**Town of Nags Head Planning Board
Nags Head Municipal Complex Board Room
Tuesday, June 18, 2024; 9:00 a.m.**

Subject: Site Plan Amendment for Inn at Whalebone, 87-unit Hotel located at 6632 W. Pheasant Avenue (W. Lakeside Street).

At this time, the applicant is requesting that consideration be given to various Site Plan amendments as well as a request to eliminate in whole, or modify, the requirements imposed by Condition #1 as it relates to the widening of Lakeside Street.

06001.00 - THE INN AT WHALEBONE, LLC - TRAFFIC IMPROVEMENTS FOR W. LAKESIDE ST.

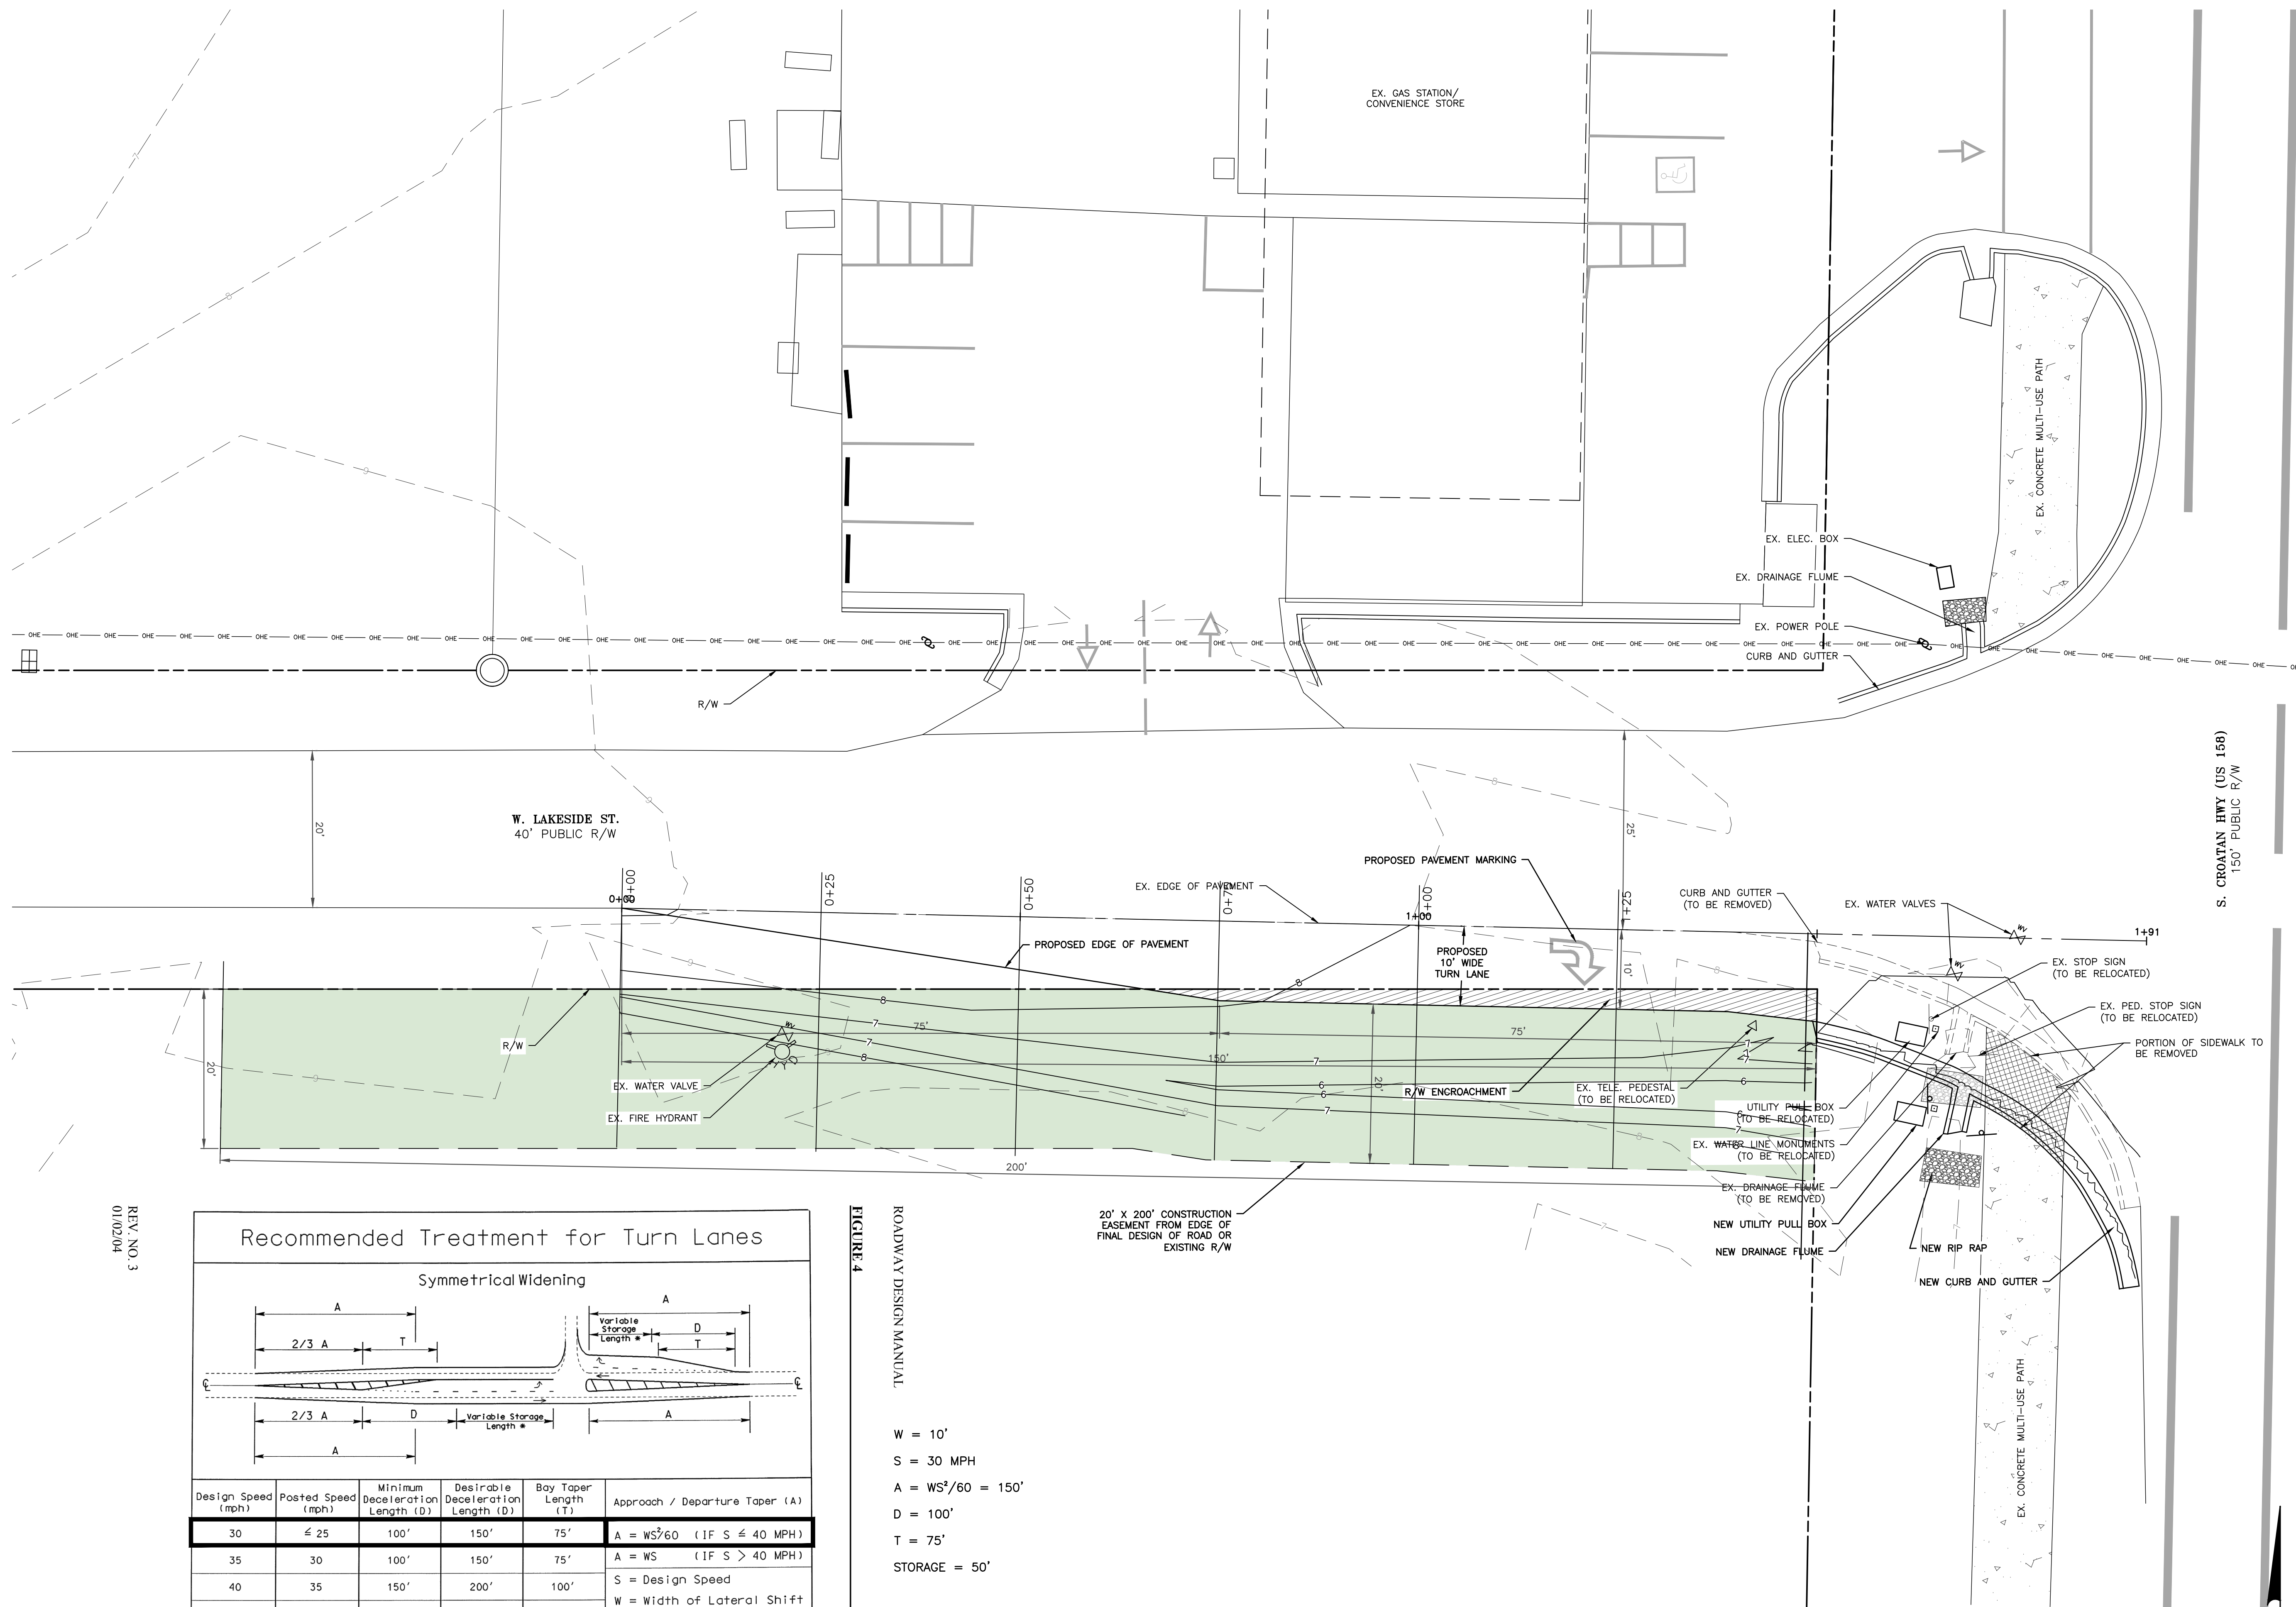
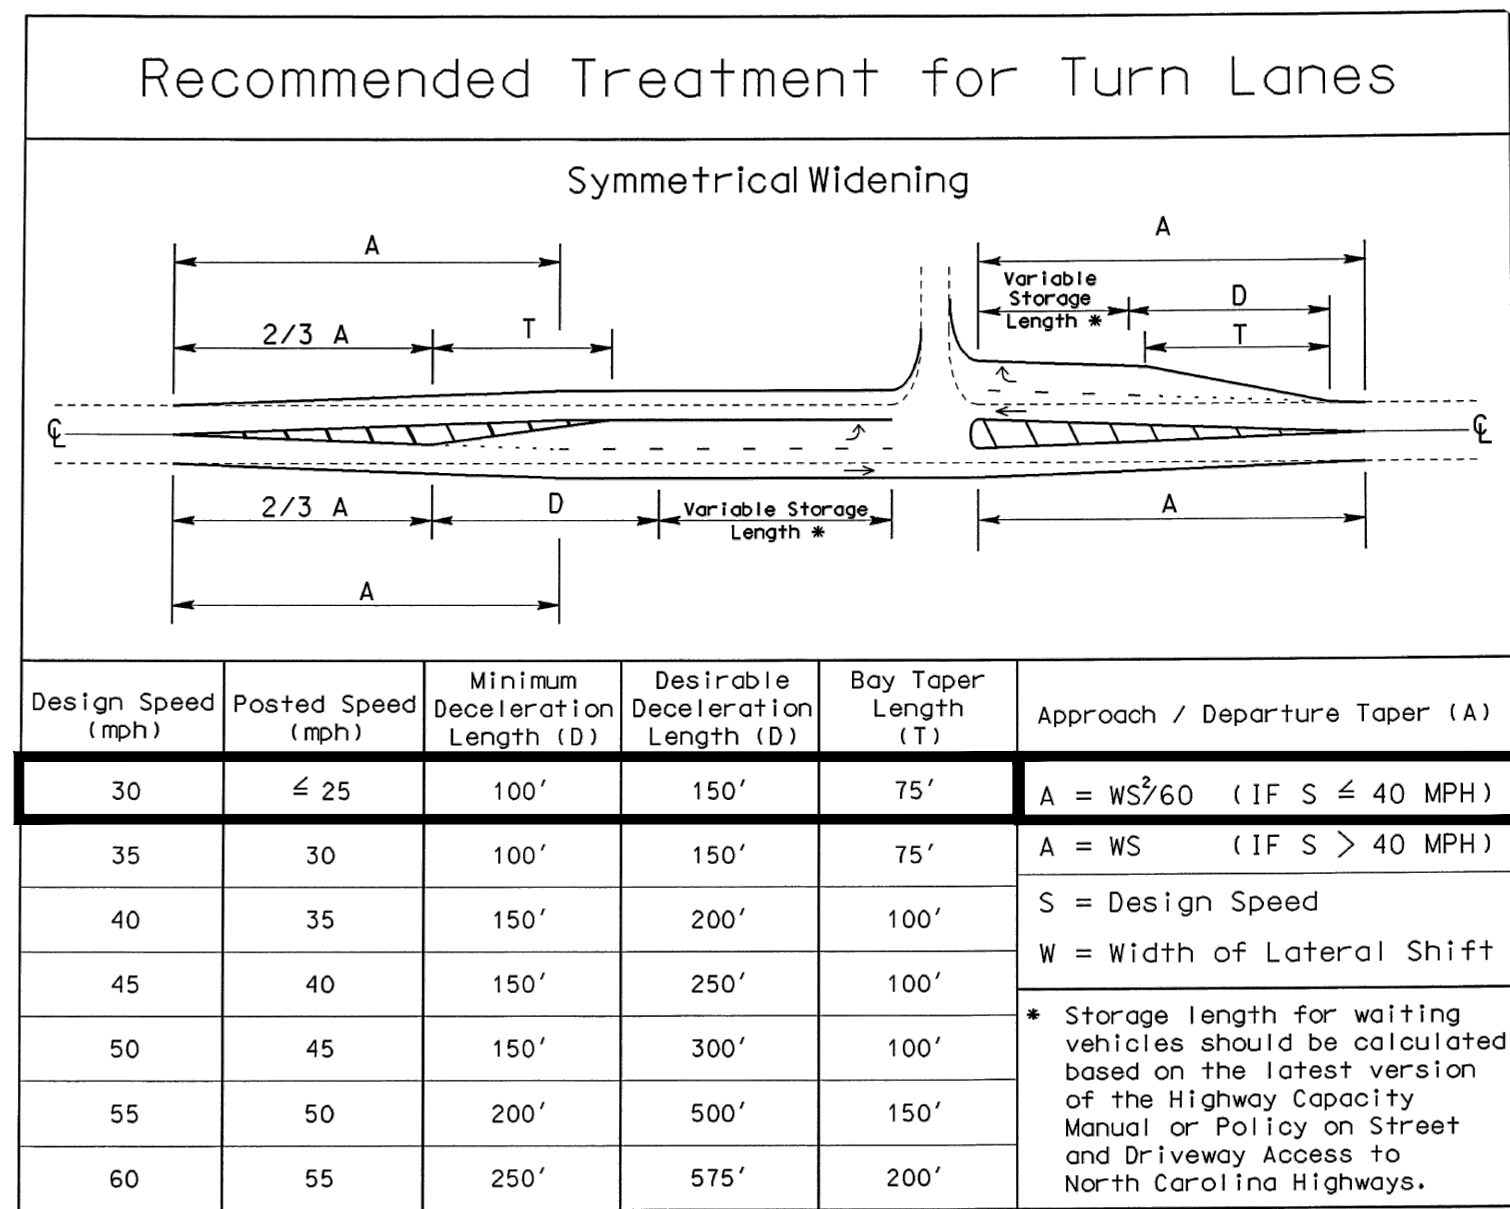
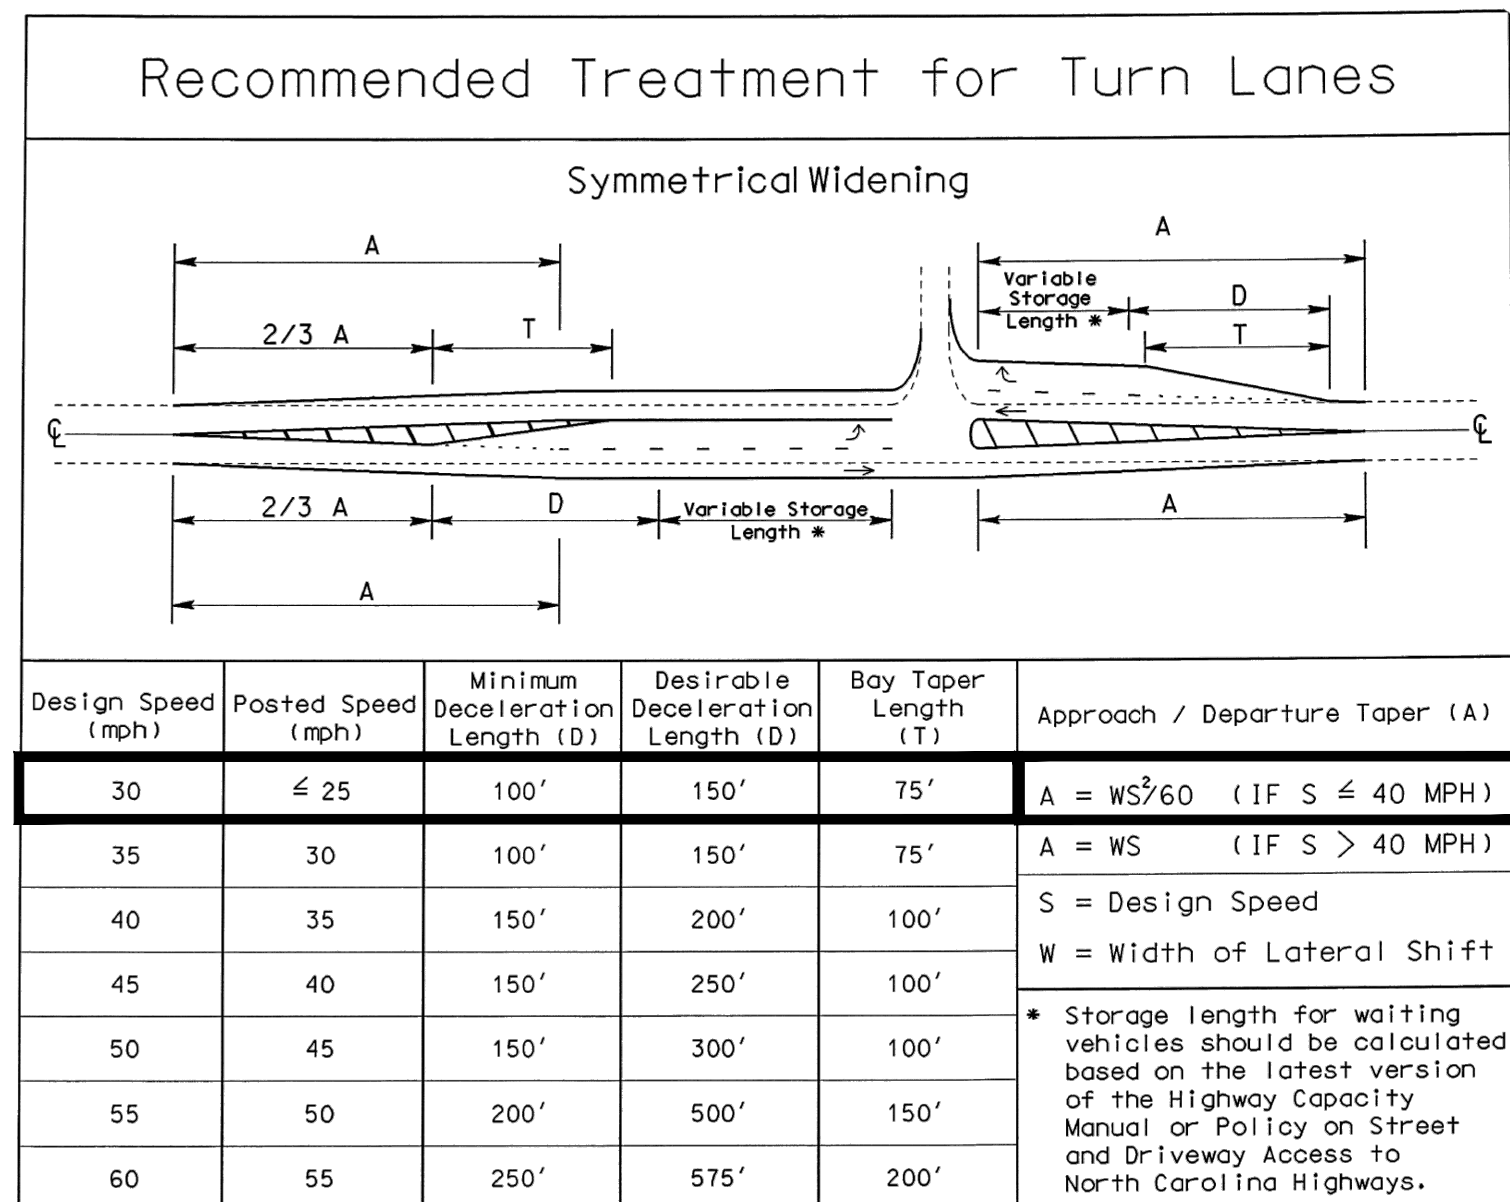
“Lakeside Street Turn Lane Exhibit- A condition was placed on the previous site plan approval to widen the Lakeside St roadway extending from S. Croatan Hwy. to the westernmost boundary of the subject property. With the existing Lakeside St. right-of-way width at 40’ there are some impacts associated with a roadway widening of this length. These impacts include runoff onto adjoining properties and potential conflicts with above ground utilities. However, there is still an opportunity to provide roadway widening to meet the intent of the previous Board of Commissioners conditioned approval.

The applicant has submitted an exhibit which shows a reduced widening plan from the eastern property boundary. This concept indicates an encroachment onto the adjoining undeveloped property to the south. Attached is an exhibit mark-up which describes a potential alternative roadway widening approach which may not result in improvements extending onto private property. The recommendation is for the applicant to modify the traffic improvements for Lakeside St. to reflect the approach as identified in the attached plan mark-up. This approval would be conditioned on the applicant acquiring detailed survey information for the development of a roadway widening and construction plan in accordance with Chapter 36-4 of the Town Code of Ordinances. It should be noted that a temporary construction easement may be required from the owner of the undeveloped property to the south for the purposes of construction in addition to a right-of-way encroachment through NCDOT.”

Regarding the applicant's request to remove or modify the condition to widen Lakeside Street, this condition was included in the October 4, 2023, Board of Commissioners (BOC) approval to address traffic concerns raised by citizens and Board members. While fully meeting this condition could impact runoff onto adjacent properties and conflict with above-ground utilities, there is an opportunity to widen a portion of the roadway. This approach would fulfill the intent of the Board of Commissioners' conditioned approval without encroaching on adjoining properties. Staff recommends that the Planning Board recommend modifying the previous BOC approval to reflect the alternative roadway design proposed by the Town Engineer.
